Supply and Demand Correlation

New Mexico – Gila Basin – Arizona Water Settlement Act

**U.S. Department of the Interior
Bureau of Reclamation
Phoenix Area Office**

Attachment A – Supply and Demand Correlation Comments/Responses

Figure 2.1. – 2005 Water Withdrawals Throughout Study Area

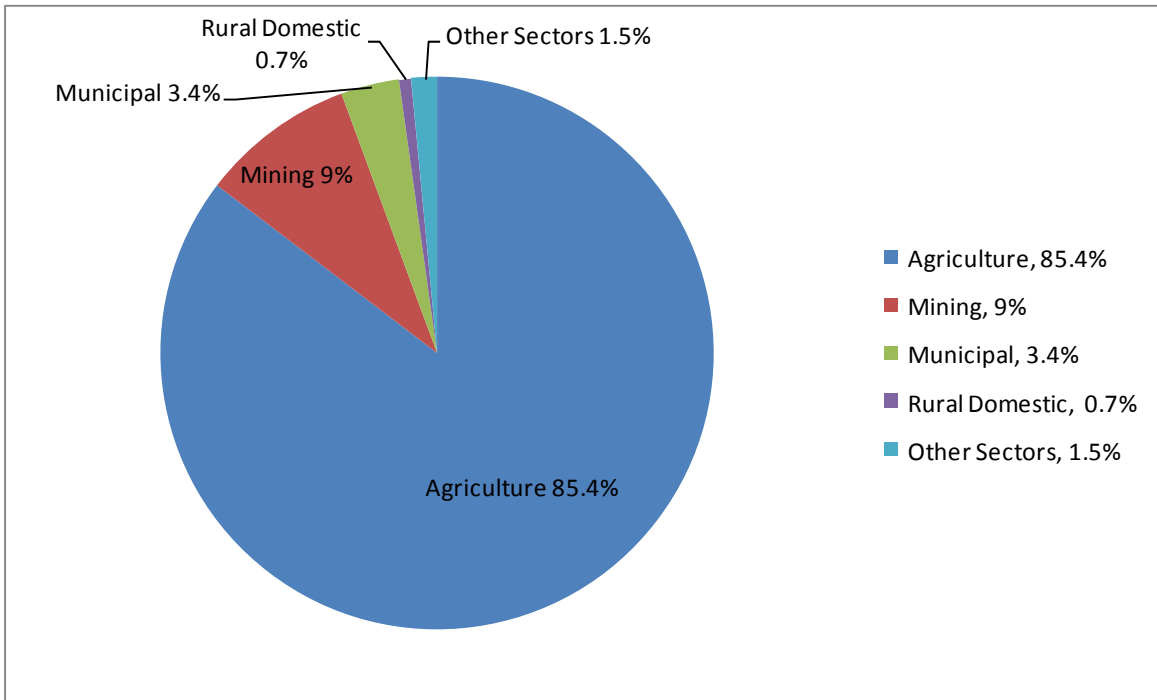
3. **P9, section 2.1.2 through section 2.1.5:** **Comment:** This section apportions water demand by sectors. It would be useful to include a pie chart that allows relative proportions of demand by sector to be easily seen.

- 8. P13, sections 2.3.2 and 2.3.3: *Comment:*** These sections forecast a 47% increase in municipal demand and a 50% increase in rural domestic demand, which seem to be large increases over 40 years, except that the proportions are relative to much bigger figures in other sectors. Municipal demand is currently 3% of total demand and may increase to 4.5% of total demand. Rural domestic demand is 1% of total demand and may increase to 1.5% of total demand. A bar graph here might help avoid misleading conclusions.

Response: A pie-chart has been added.

Response: The pie-charts in AMEC’s Figures ES-1, -2, and -3 address this comment.

Figure 3.1. – Map of Southwest New Mexico Planning Area

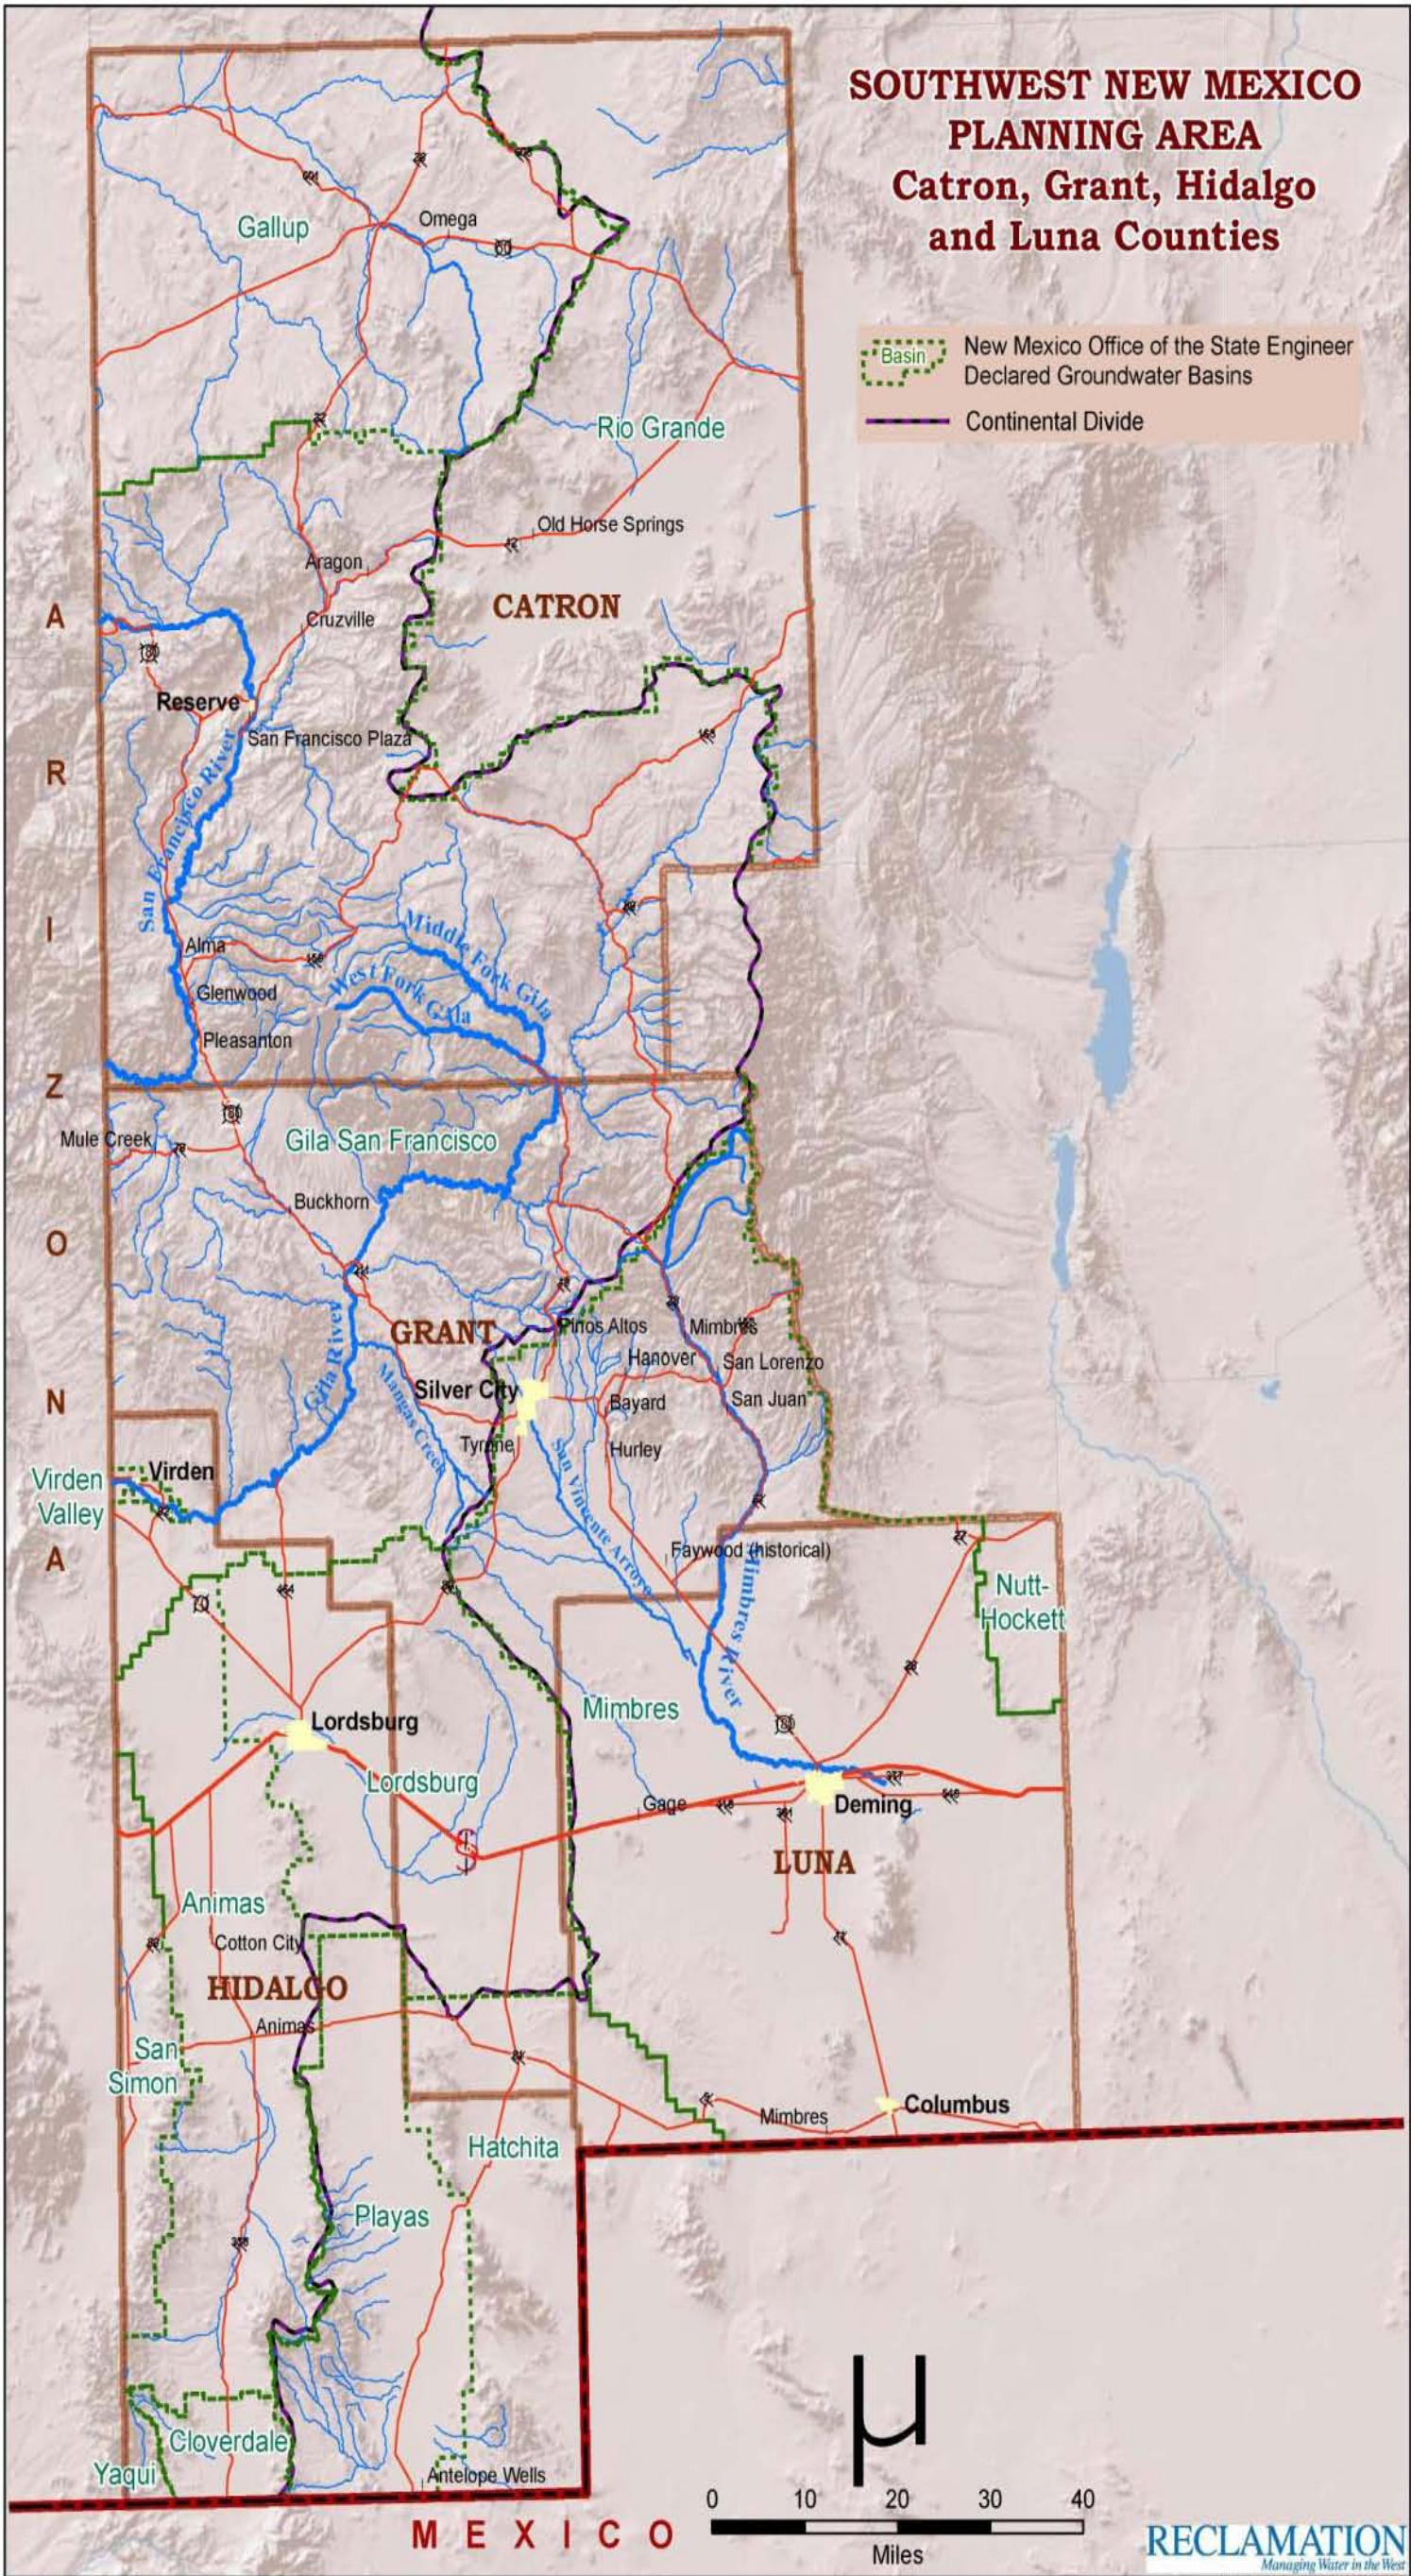
- 3. P4, section 1.2, par 4: *Comment:*** Does SSPA specify where or in different locations?

Response: SSPA did mention recent monitoring of alluvial observation wells installed along four transects across the Gila River (Figure 3.1) in the Gila-Cliff Valley. It is interpreted the statement refers to the four transects (FM-1, FM-2, Bird, and TNC transects; see Fig. 3.1) and intervening seepage investigation measurement areas (see Fig. 3.8) along the Gila River in their two Riparian models, in Reaches 1 and Reach 2. These two model areas occur between Mogollon Creek at Gila River to the north, and below Mangas Creek where it joins the Gila. They were able to characterize gains and losses in reaches between the USGS gage Gila River near Gila (09430500) and the Bird Area, which is located upstream of the Middle Box area.

The text was rewritten to better clarify the location.
